SUBJECT: Responds to RAI re proposed amend concerning thermal power update.

Re: Turkey Point Units 3 and 4
Docket Nos. 50-250 and 50-251
Request for Additional Information (RAI)
Proposed License Amendments
Thermal Power Uprate

Response to NRC Request
for Additional Information
Related to Thermal Power Upgrading
at Turkey Point Units 3 and 4

MAIN STEAM LINE BREAK
CORE RESPONSE CURVES

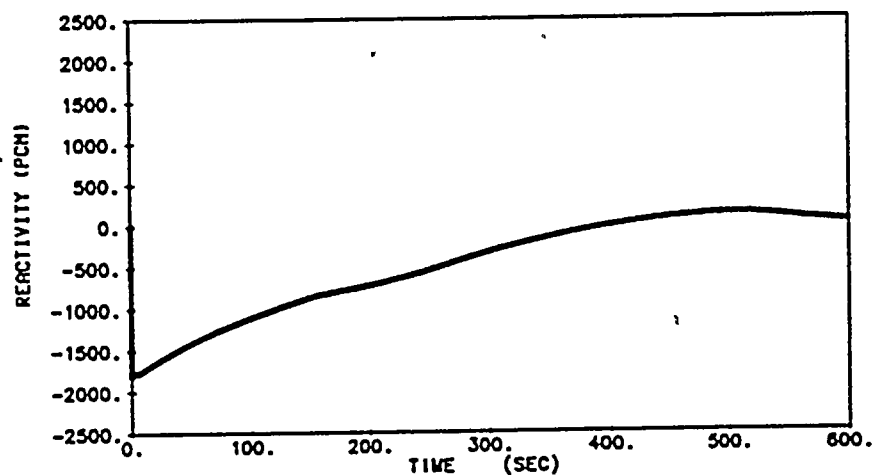
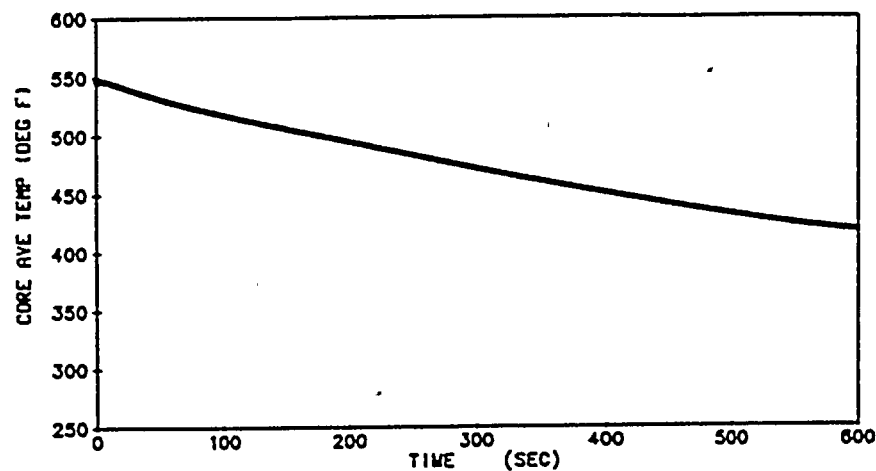
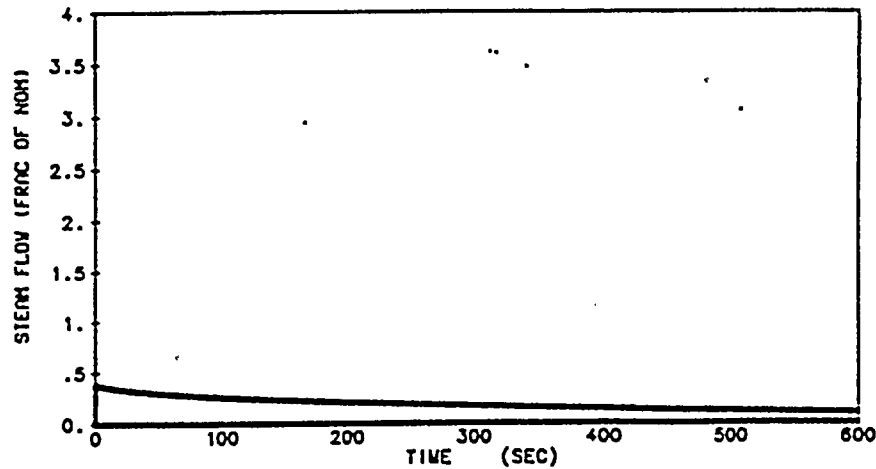
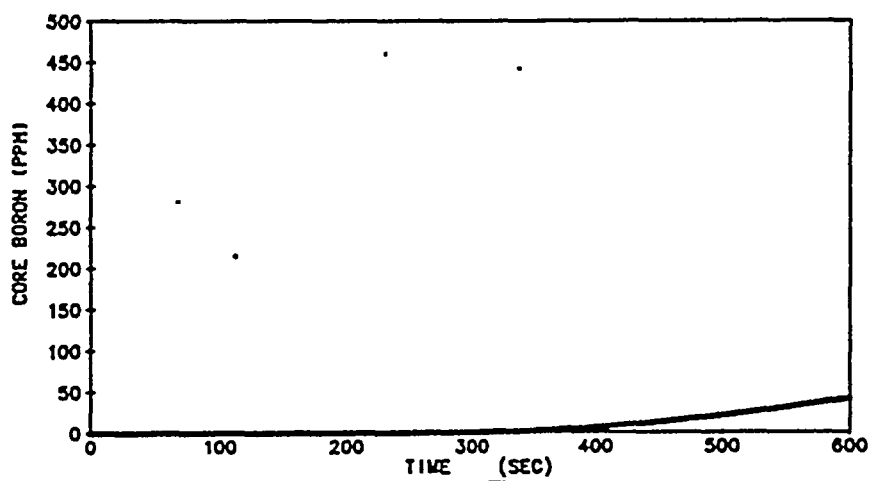
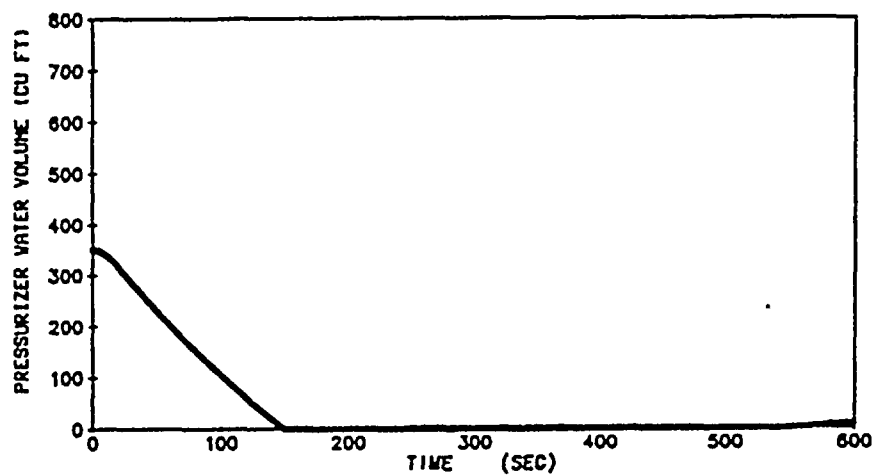
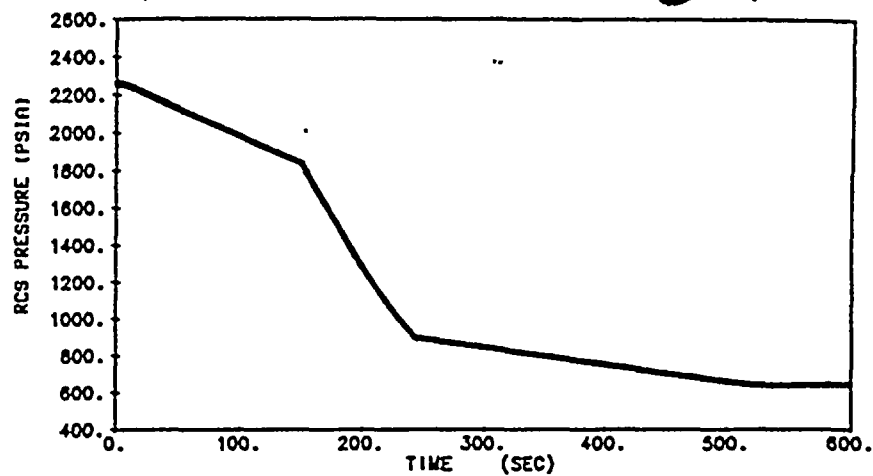
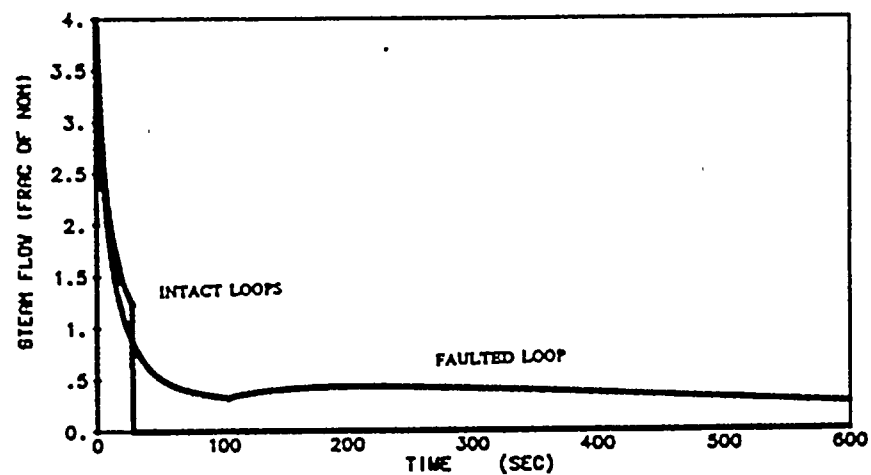
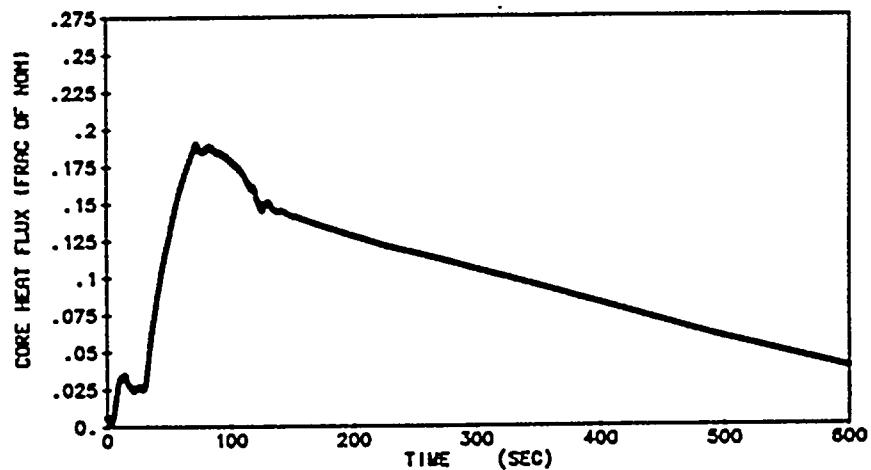
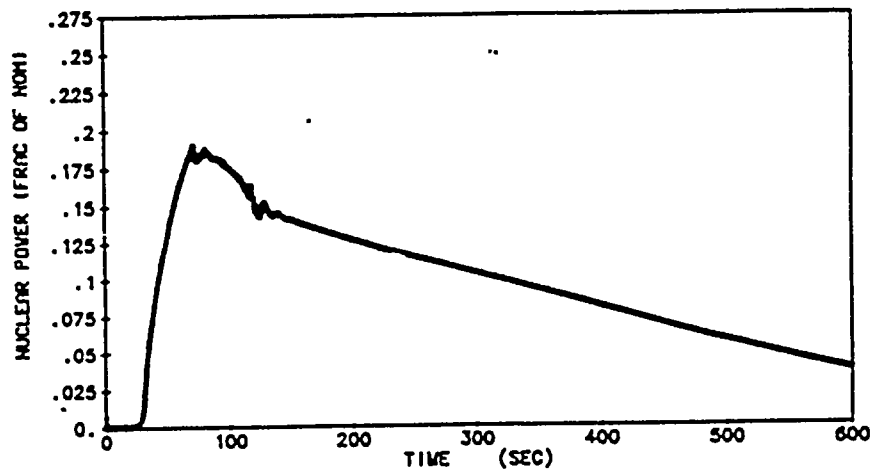
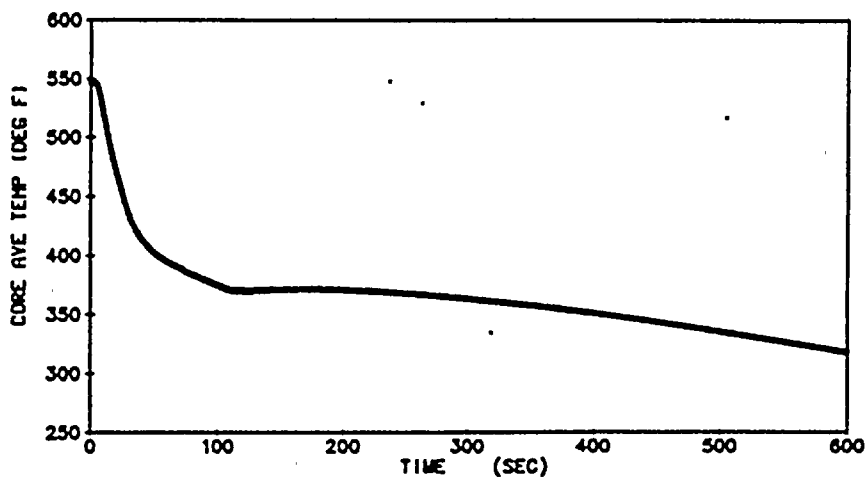
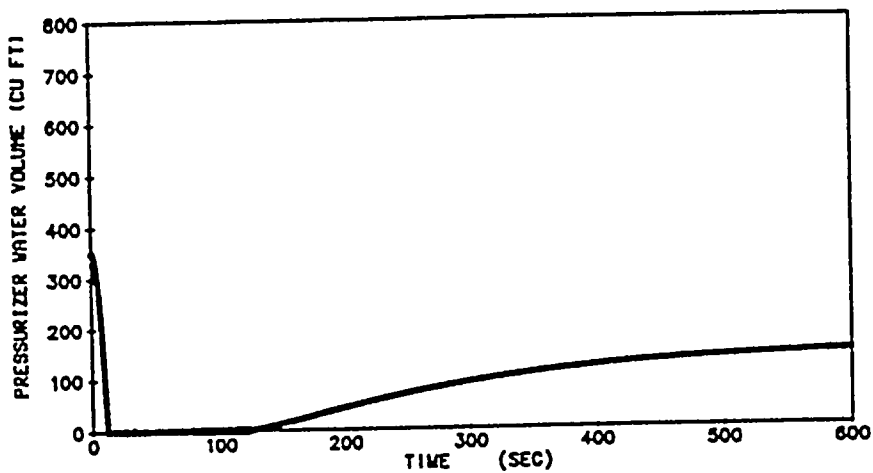
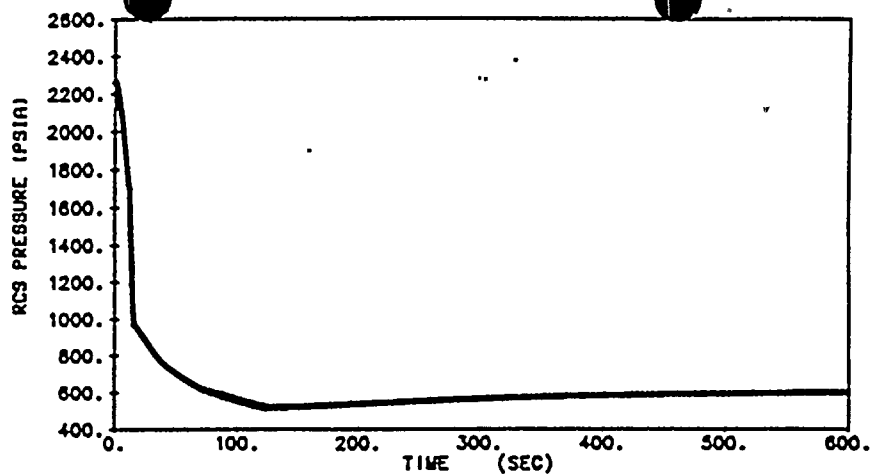
5. "Provide major transient curves for the reanalysis of the postulated main steam line break."

The Main Steam Line Break (MSLB) core response analysis is performed at Hot Zero Power (HZIP) conditions, which did not change for the power uprating, and the HZIP stuck rod coefficients remained applicable for uprated conditions since these are calculated at HZIP and

parameters affecting these coefficients (mainly the moderator density coefficient) have not changed for the power uprating conditions. Therefore, the analysis performed under the RTDP project is not affected by the uprating and the DNBR design basis continues to be met. The curves associated with the proposed UFSAR write-up for the MSLB event are attached.
